PROJECT:
FPCC, LIDCOMBE

DRAWING TITLE:
CAR PARK REVIEW
AV ACCESS (19m SEMI-TRAILER)

DRAWING TITLE:
CAR PARK REVIEW
AV SUBSTATION ACCESS
(19m SEMI-TRAILER)

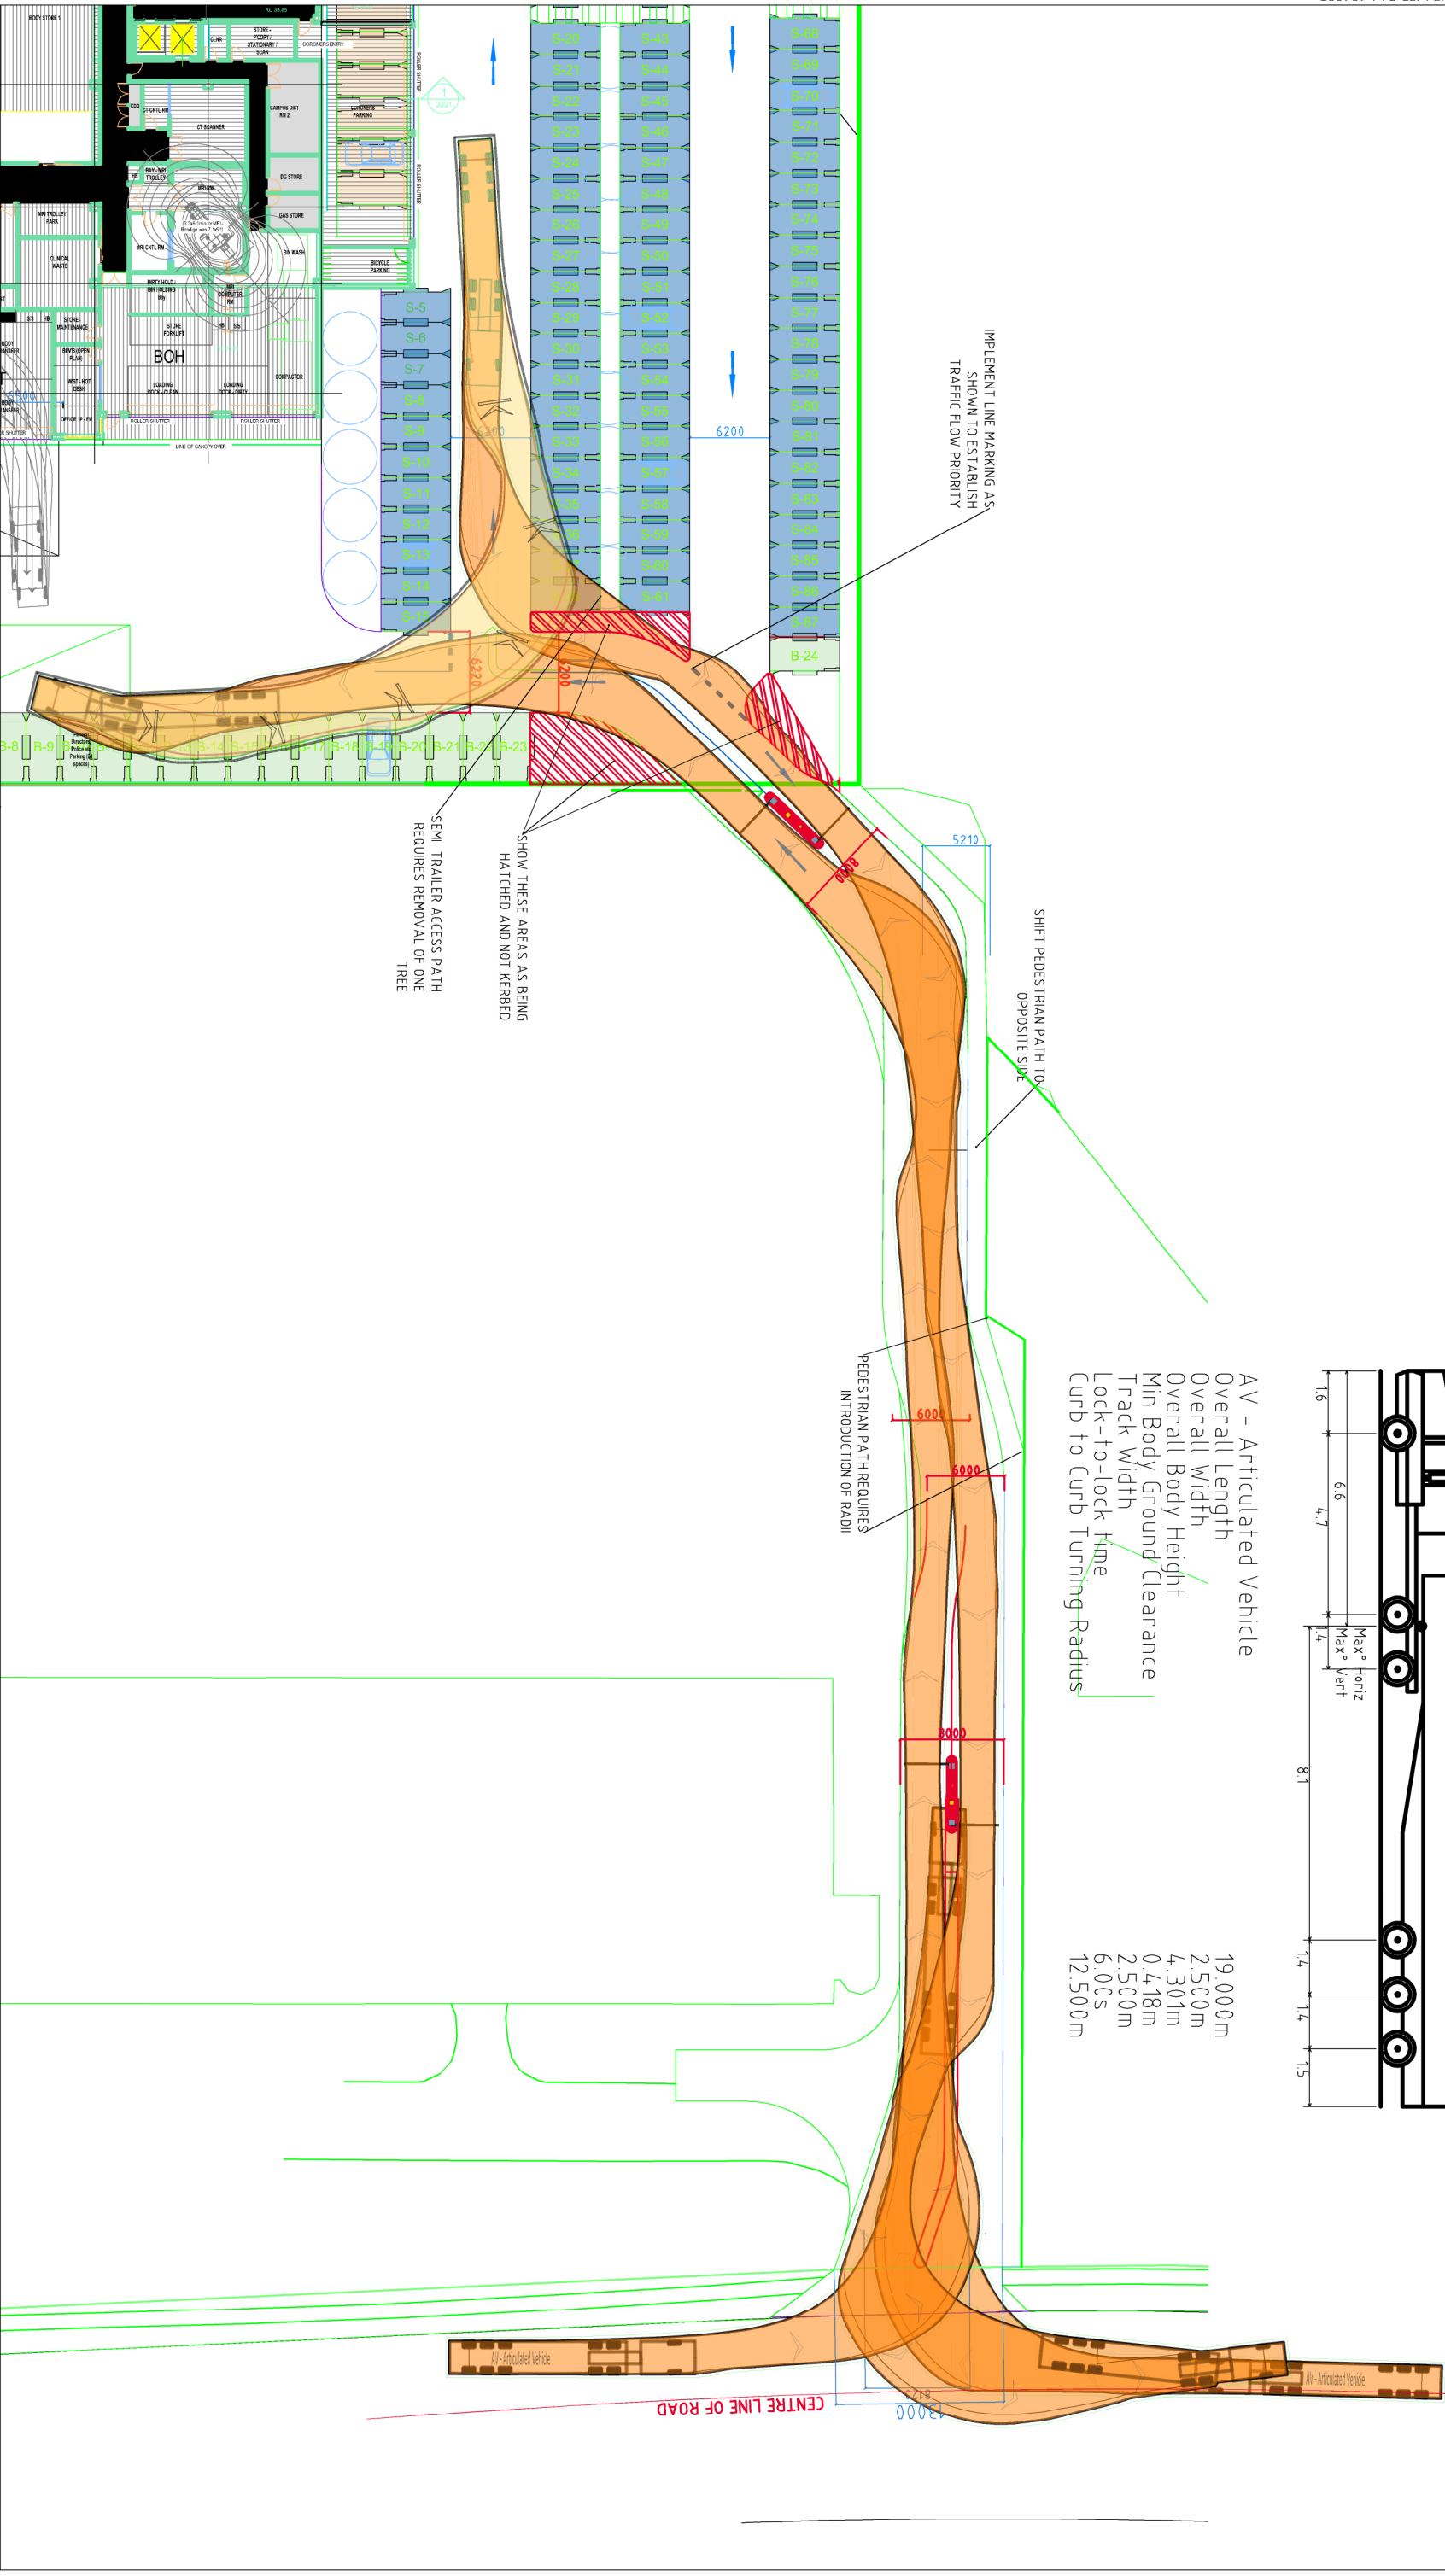
Please note the following compliance requirements:

Height Clearance: 4.5m wherever access is required for a heavy vehicle (and safety clearance envelope)
